2202221180 WGM160P Software, Marking and Datasheet 1.2 Update

Bulletin Issue Date: Feb 22, 2022

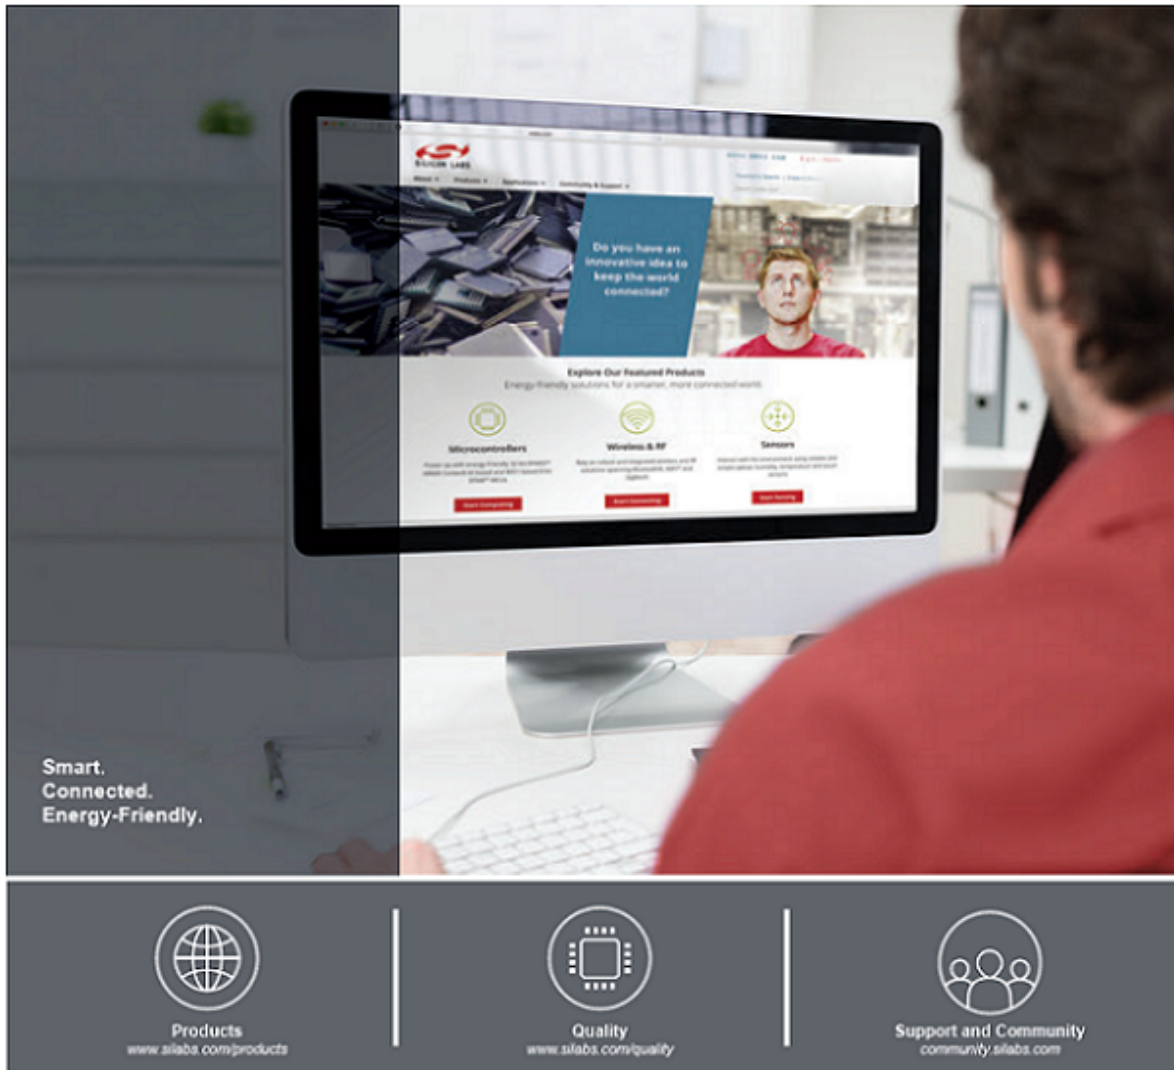
Silicon Labs also announces marking updates for new regulatory certifications/compliance in the UK. As of the effective date of this notification, customers may receive mixed product with old and new markings until Silicon Labs inventory with old markings is depleted.
